Release Note

Edgecore EAP104 Release v12.4.1

Document # EAP104-v12.4.1-1048-f462f4f3

Enhancement from v12.4.0-980-c4ad2d45

1.1 Access Control List Enhancement

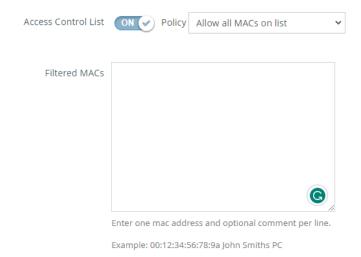
The original number of MACs in the access control list is 128. In this version, the number of MACs is increased to 512 for all policys.

1.4 Hostname Enhancement

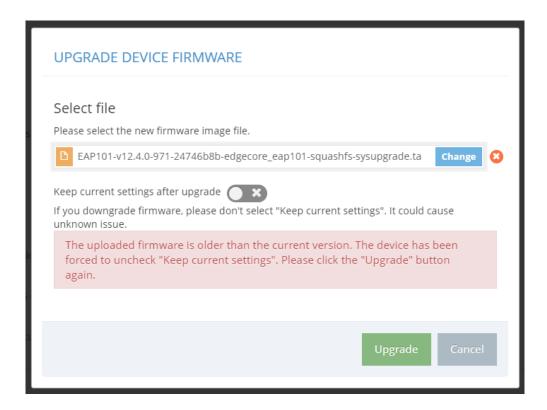
Add the validation for Hostname below.

1. Hostname – Must be between 1 and 63 characters long. The only characters allowed in the device hostname are ASCII letters, numbers, and dashes.
